OC PUBLIC WORKS
SANTA ANA, CALIFORNIA
RECORD DRAWINGS
PLANS FOR CONSTRUCTION OF
EDINGER AVENUE BRIDGE
OVER SANTA ANA RIVER CHANNEL
WIDENING PROJECT
BR. NO. 55C-0154
FROM
200' EAST OF HARBOR BOULEVARD
TO
1600' WEST OF FAIRVIEW STREET
W.O. NO. ER09342

SHEET	DESCRIPTION
1	TITLE SHEET
2	CONSTRUCTION NOTES
X-1	TYPICAL SECTIONS
UT-1	UTILITY PLAN
P 1-3	PLAN AND PROFILE
P-4	OCFCD ACCESS ROAD DETAILS
P-5	FRONTAGE ROAD DETAILS
D 1-2	DRAINAGE DETAILS
G 1-3	GRADING PLAN
C 1-3	CONSTRUCTION DETAILS
SC 1-5	STAGE CONSTRUCTION
TH 1-9	TRAFFIC HANDLING
PD 1-2	PAVEMENT DELINEATION
S 1-2	SIGNAGE
SQ 1	SIGN QUANTITIES
E 1	ELECTRICAL
RW 1-5	RETAINING WALL PLANS
LS 1-2	IRRIGATION PLAN
LS 3-4	IRRIGATION DETAILS
LS 5-6	PLANTING PLAN
LS 7	PLANTING DETAILS
ST 01-27	STRUCTURE PLANS
77-83	BRIDGE MAINTENANCE PLANS

AS BUILT

EDINGER AVENUE BRIDGE OVER
SANTA ANA RIVER CHANNEL
WIDENING PROJECT
BR. NO. 55C-0154
TRAFFIC
HANDLING
STA 10+75 TO STA 28+00

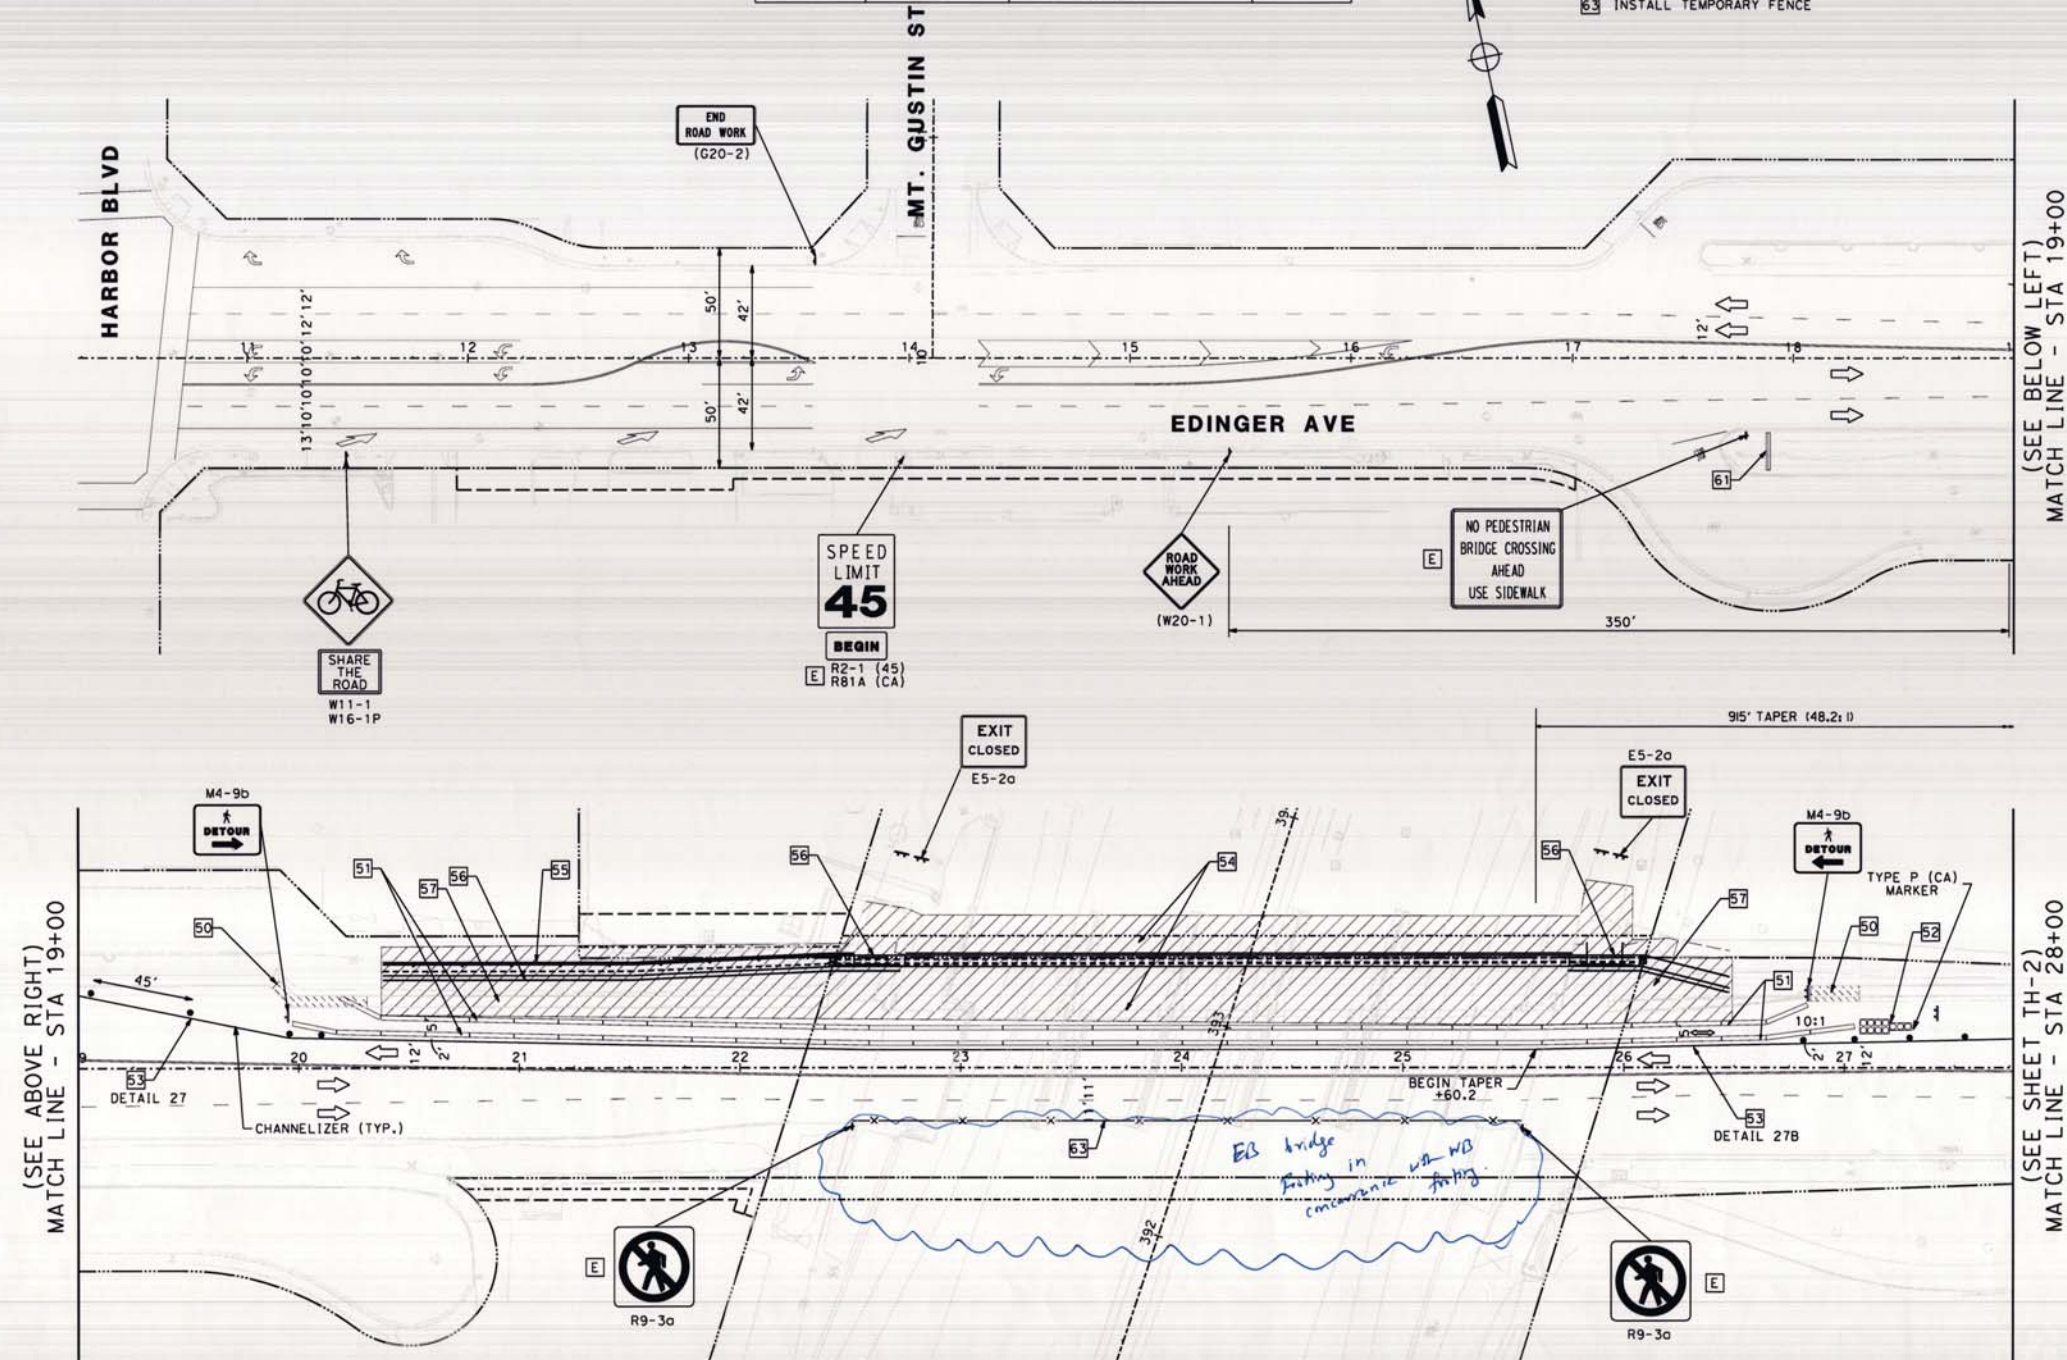
Note -
Traffic control plan was followed
per sheet, except EB bridge
construction was included in
stage-1.
Traffic control equipment / strip
approved by County design.
conformance with City of F/A.
